UNITED STATES PATENT AND TRADEMARK OFFICE

| APPLICATION NO. | FILING DATE | FIRST NAMED INVENTOR | ATTORNEY DOCKET NO. | CONFIRMATION NO. |
|--|-------------|----------------------|---------------------|------------------|
| 10/712,269 | 11/14/2003 | Vernon R. Brethour | 28549-198910 | 7955 |

DETAILED ACTION

APPENDIX A

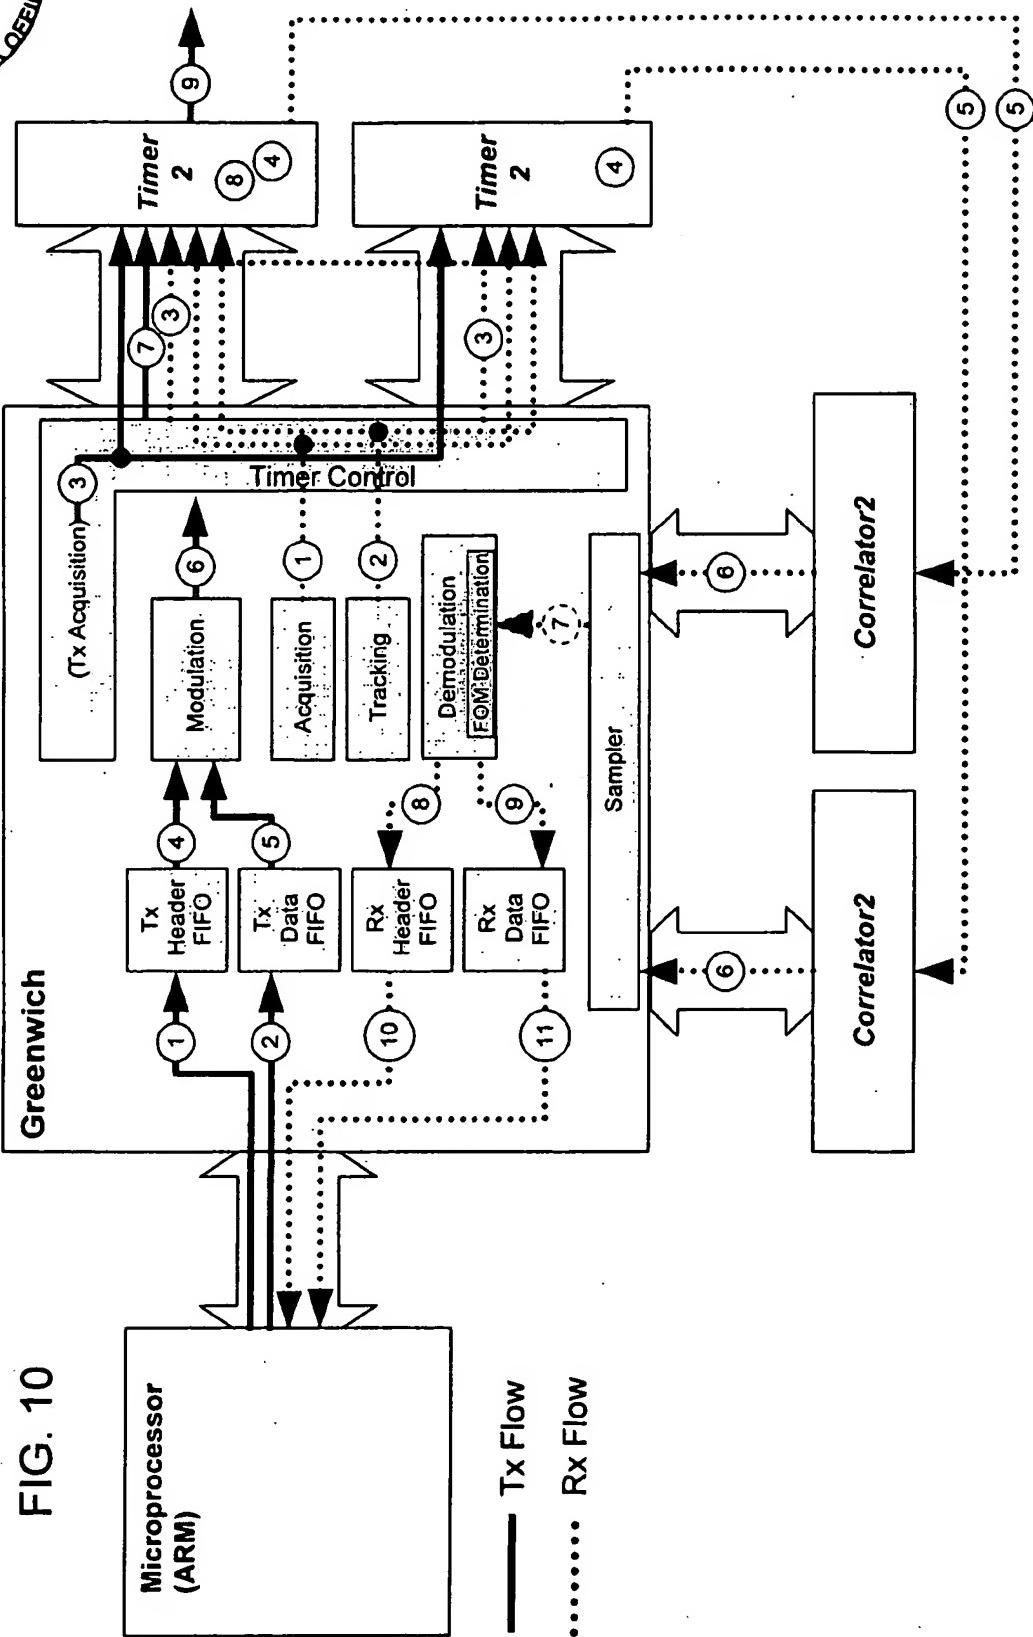
3. The drawings were received on May 13, 2005. These drawings are not accepted because it does not comply with 37 CFR 1.84(c) which requires the drawing sheet to be identified as a replacement sheet. Appropriate correction is required.

Not accepted
